ADDENDUM 1

DATE: April 18, 2024

PROJECT: OUSD, Wagner Ranch Elementary School Path of Travel Work

FROM: HKIT Architects

DSA APP# 64618

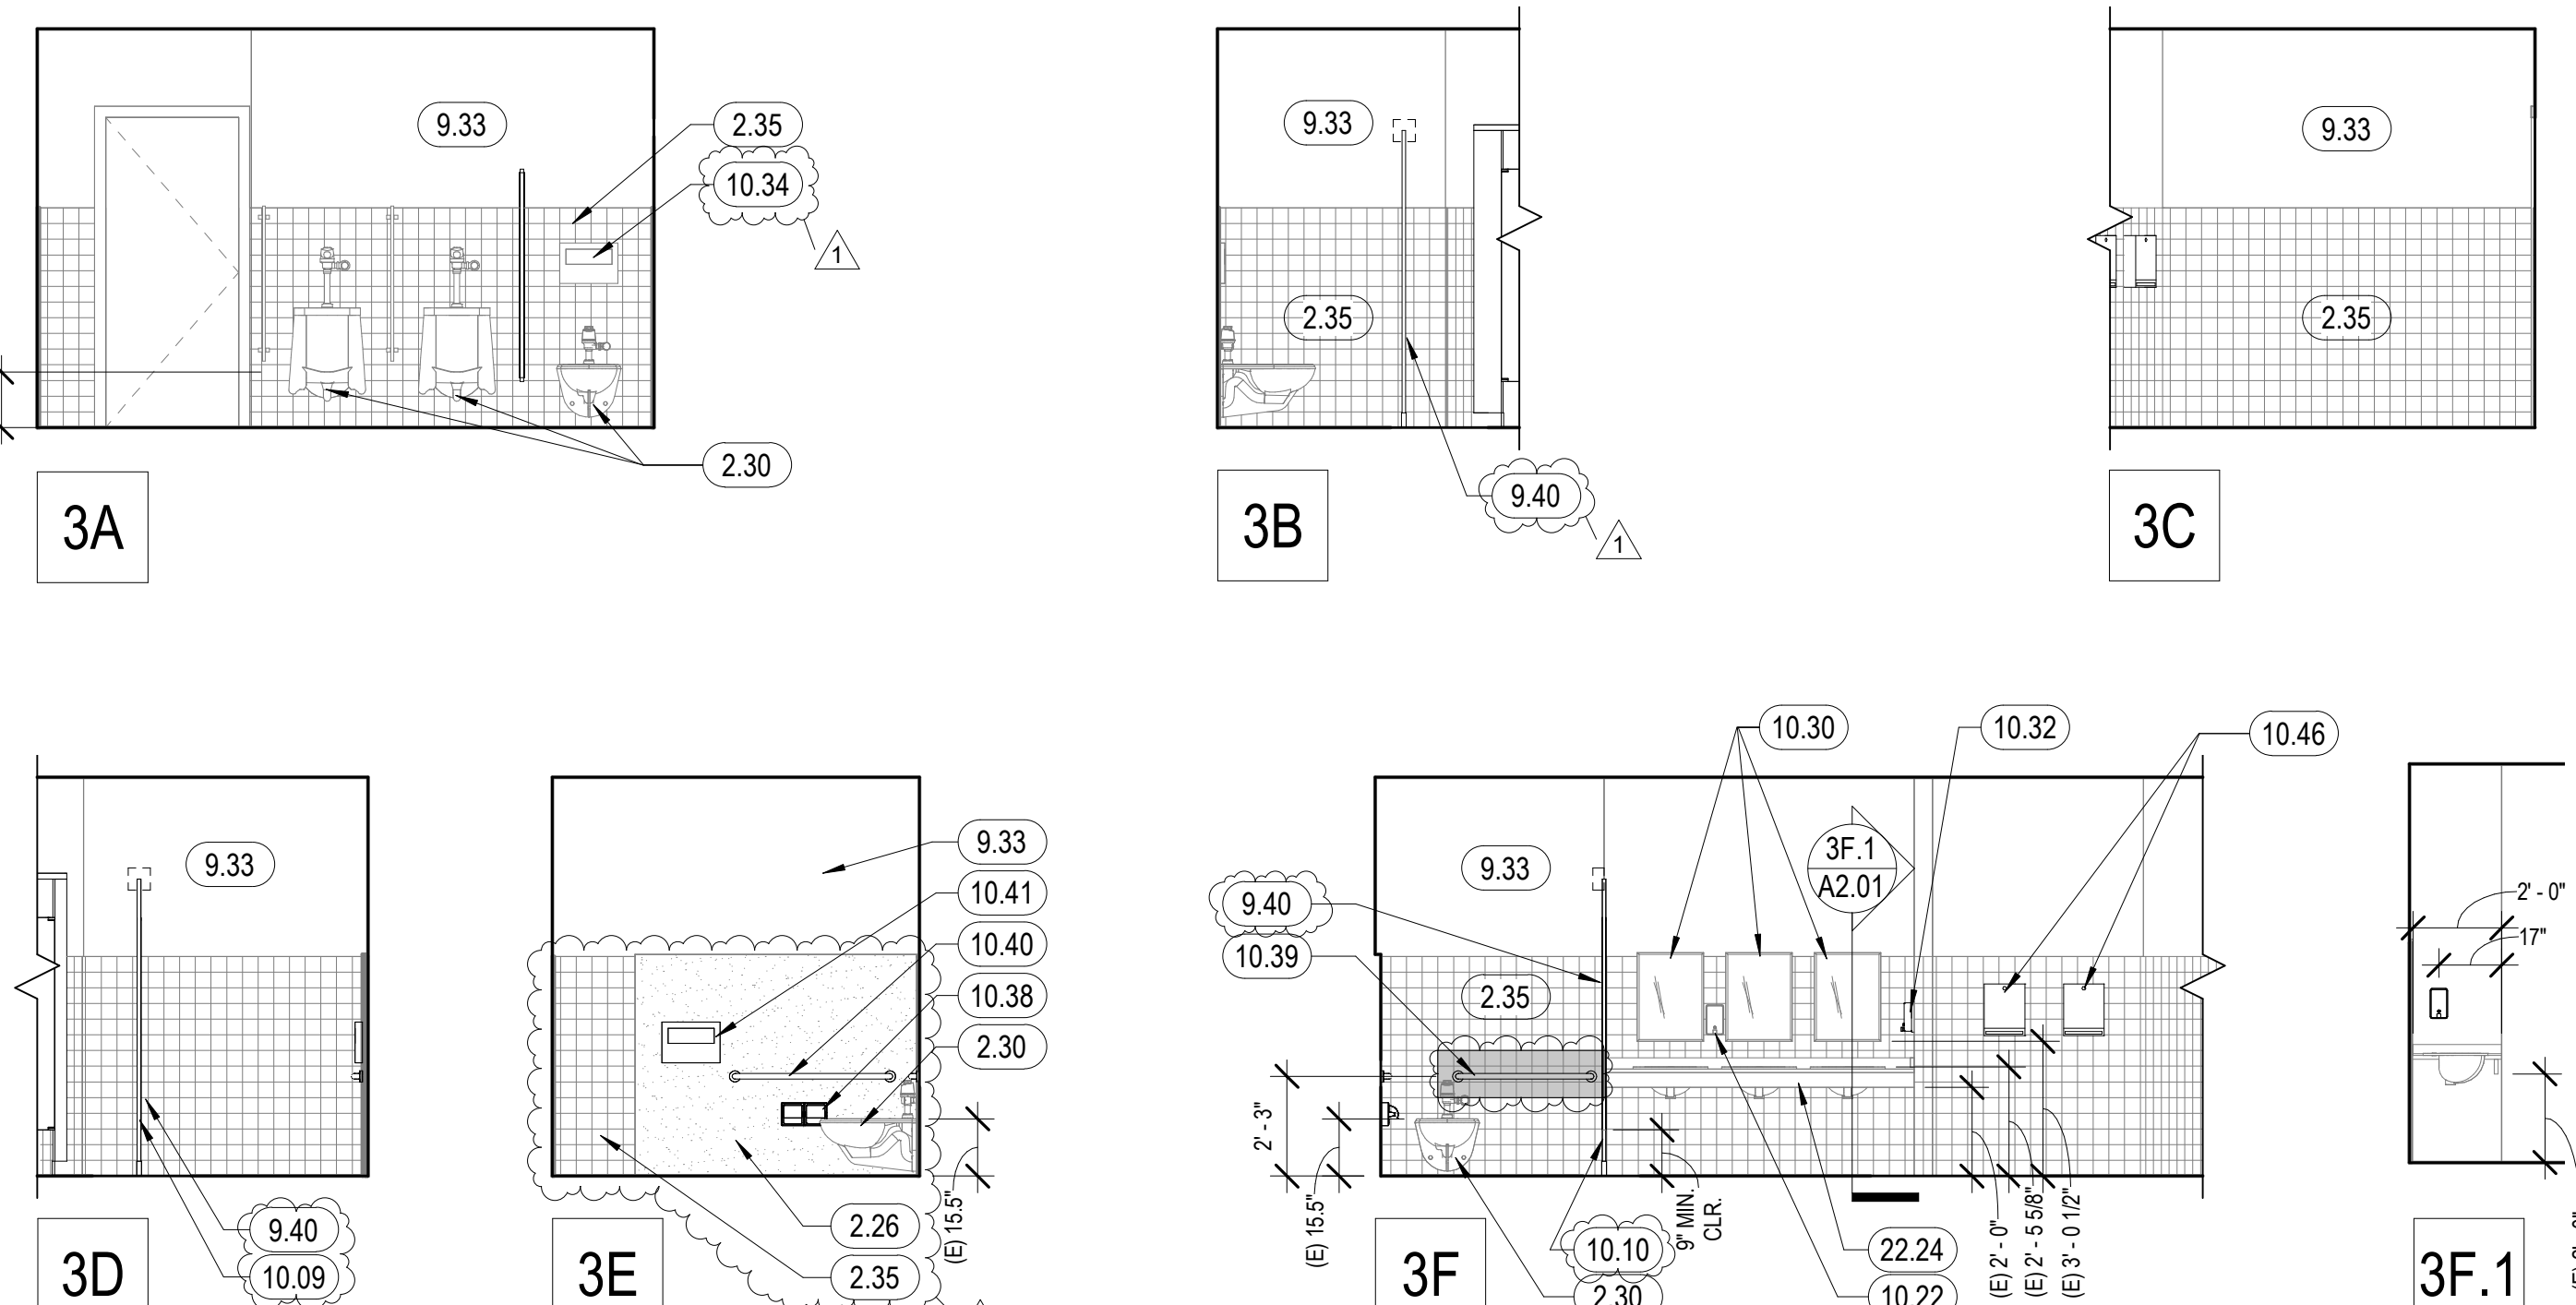
1-3 Subject: Accessibility upgrades at toilet rooms.

Description of Change: Provided additional dimensions and keynotes to clarify scope and required changes to toilet rooms. Revised blocking details for accessories and grab bars at A2.03
